# SAFETY RECALL NOTICE

## **Re: Can-Am® Spyder® Roadster – Tandem Master Cylinder Manifold Inlet - Fire Hazard**

Subject: **Can-Am™ Roadster - Tandem Master  
Cylinder Manifold Inlet- Fire Hazard**

No. **2013-8**

TYPICAL - VIEW FROM RIGHT SIDE

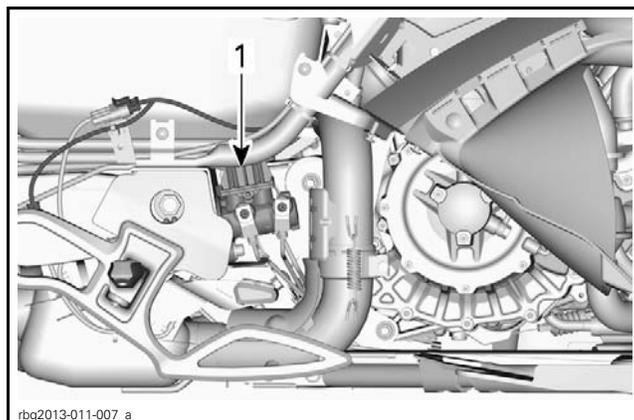
With the tandem master cylinder still installed on the vehicle, visually inspect the tandem master cylinder manifold inlet for signs of deformation.

1. Tandem master cylinder manifold inlet

SITUATION	TO DO
ACCEPTABLE ✓	Install all reflective heat shields and the heat deflector as per the procedure described in this bulletin.
NON-ACCEPTABLE ✗	Replace the tandem master cylinder, refer to <i>SERVICE BULLETIN 2013-9</i> for the latest procedure. Install heat deflector and all reflective heat shields.

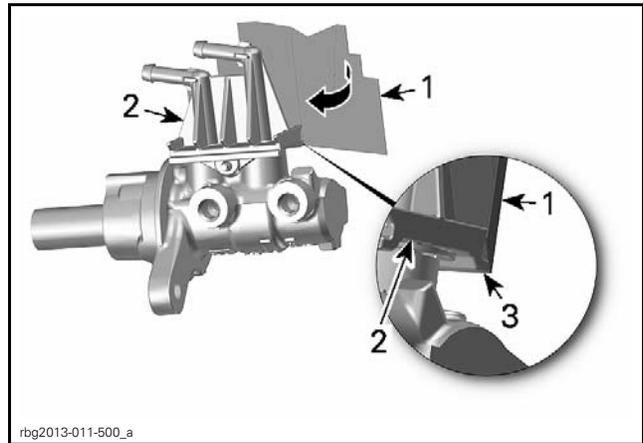
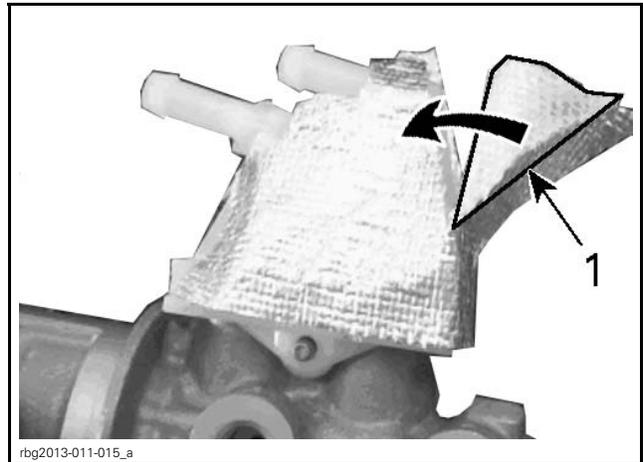
4. Remove the rest of the protective backing. Slide the reflective heat shield between the frame support and the tandem master cylinder manifold inlet aligning the lower edges together.

**NOTICE** Make sure lower edges of heat shield and manifold inlet are properly aligned.

1. Heat shield
2. Manifold inlet
3. Lower edges perfectly aligned

PROPER AND IMPROPER INSTALLATION

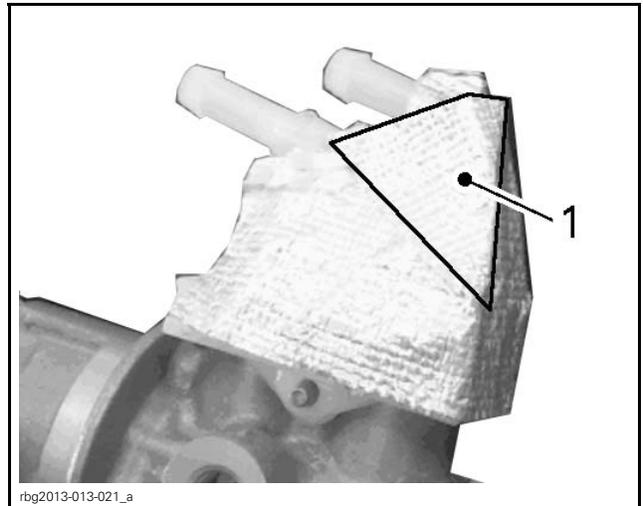
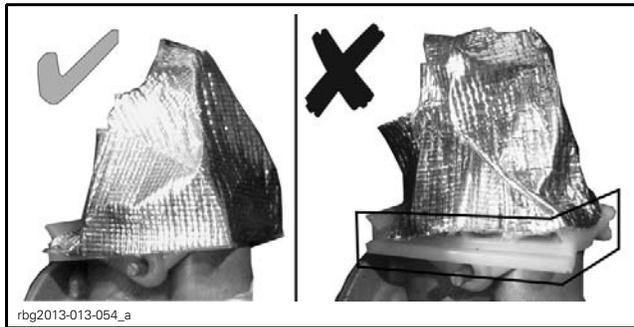
5. Fold the two tabs on tandem master cylinder manifold inlet to finish the installation.

1. Unfolded tabs

1. Folded tabs

VIEW BEHIND TANDEM MASTER CYLINDER

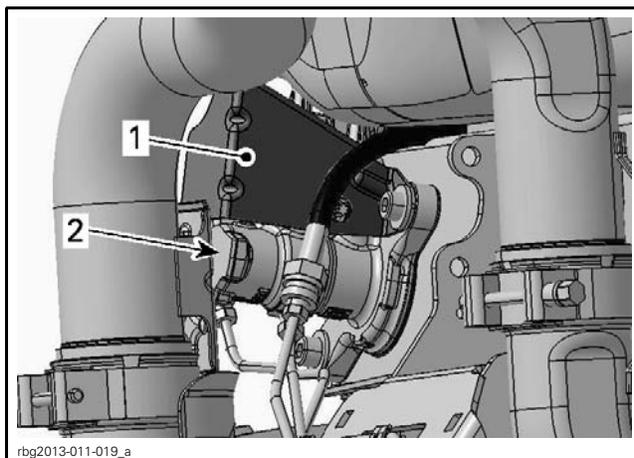
7. Insert the heat deflector [P1]; make sure the tandem master cylinder manifold inlet retaining pin is centered with the hole.

1. Installed heat deflector
2. Tandem master cylinder

VIEW FROM RIGHT SIDE

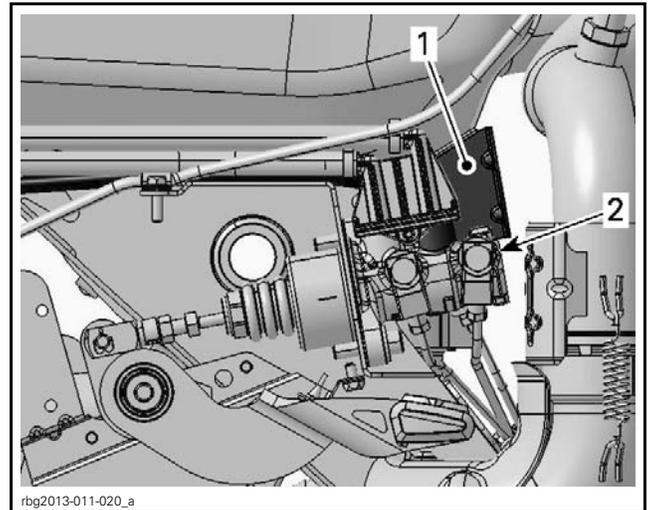
1. Heat deflector in place
2. Tandem master cylinder

9. Replace the outer tandem master cylinder screw (Allen screw) with the remaining M8 X 30 hexagonal flange screw [P5].

TIGHTENING TORQUE	
M8 X 30 hexagonal flange screw [P5]	24.5 N•m ± 3.5 N•m (18 lbf•ft ± 3 lbf•ft)

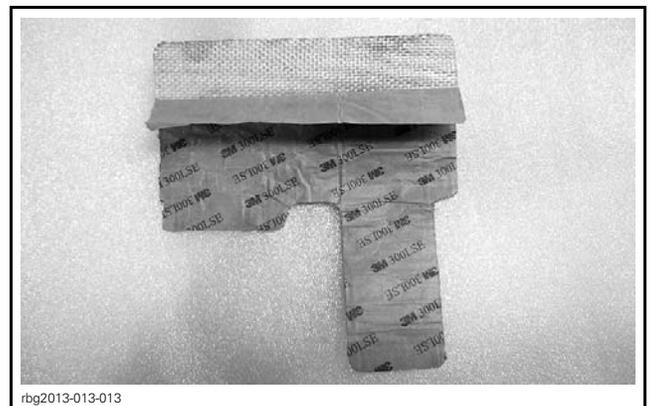
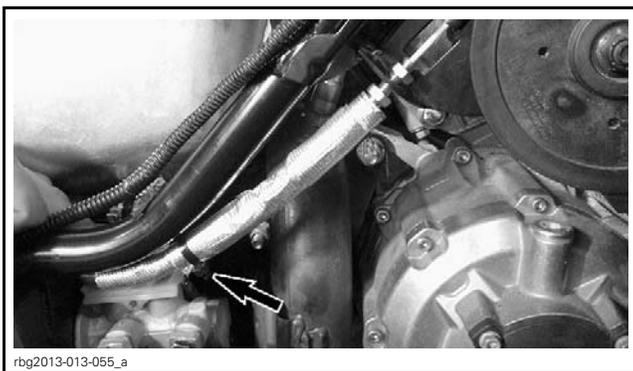
2. Peel off approximately 25.4 mm (1 in) of the back paper of the reflective heat shield [P4].

3. Start the installation by applying as shown and roll the heat shield around the brake cable as tight as you can.

**NOTICE** Make sure the heat shield edge leans against the parking brake cable nut.

4. To prevent the unsticking of the heat shield, install a locking tie [P8] at the bottom end of the heat shield.
